RPRC DETERMINATION LETTER

Project Description: Wetlands permit
Street Location: 84 ROUND HILL RD
Zoning District: R-2A Tax ID: 102.03-1-39 Application No.: 2022-0106
RPRC DECISION: RPRC - Requires Planning Board
Date: 02/15/2022

Notice of Violation

Re: Violations of Environmental Conservation Law Article 24 at 84 Round Hill Road, Town of North Castle, Westchester County

Landscape & Wetland Buffer Mitigation Plan

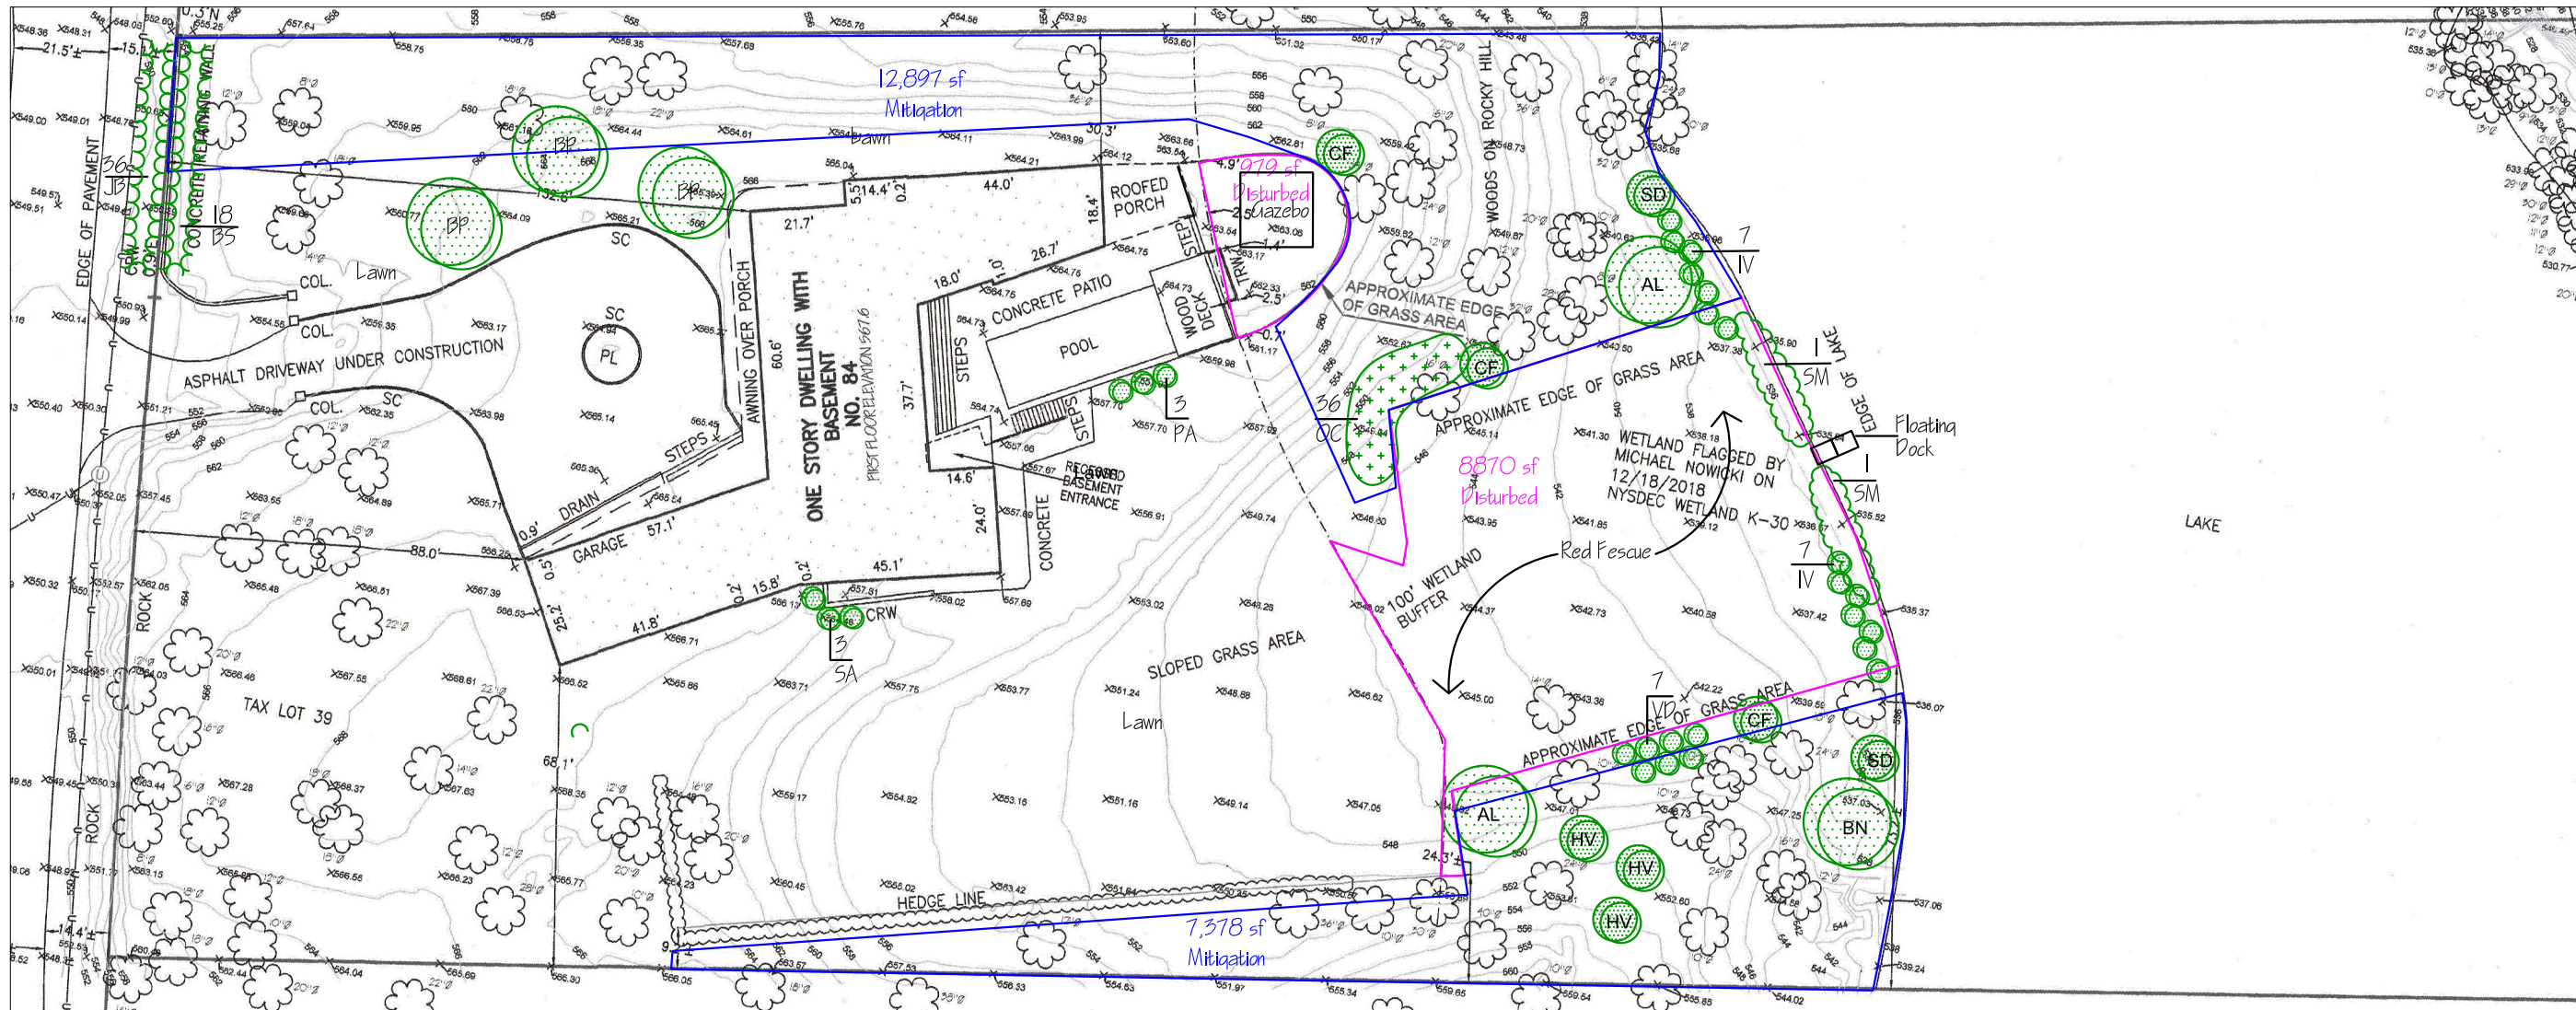
- Additional retaining walls beyond what is depicted on the plan have been installed within the front yard without prior approval. The plan shall be revised to include the location of the constructed retaining walls based upon an As-Built Survey. If found to be installed within the Town right-of-way, the walls must be removed and relocated. The plan shall be updated accordingly.

- The plan proposes disturbances within the locally-regulated 100-foot wetland buffer and the NYSDEC 100-foot wetland adjacent area associated with Freshwater Wetland, K-30. A local Wetland Permit and NYSDEC Freshwater Wetland Permit is required. The applicant has illustrated the NYSDEC wetland boundary and regulated 100-foot adjacent area on the plan for verification by the Town Wetland Consultant. Notify the Town Engineer once the wetland boundary has been established in the field. The applicant will be required to provide a wetland validation by the NYSDEC and obtain a NYSDEC Freshwater Wetland Permit.

- The applicant will be required to prepare a Wetland Mitigation Plan in accordance with Chapter 340, Wetlands and Watercourse Protection, of the Town Code. It is noted that the original application included no disturbance to wetland or wetland buffers.

- The site detail sheet illustrates a patio section that is unlabeled. If not required, this detail should be removed from the plan.
- The Landscaping Plan shall be revised to coordinate with the Site Civil Plans.
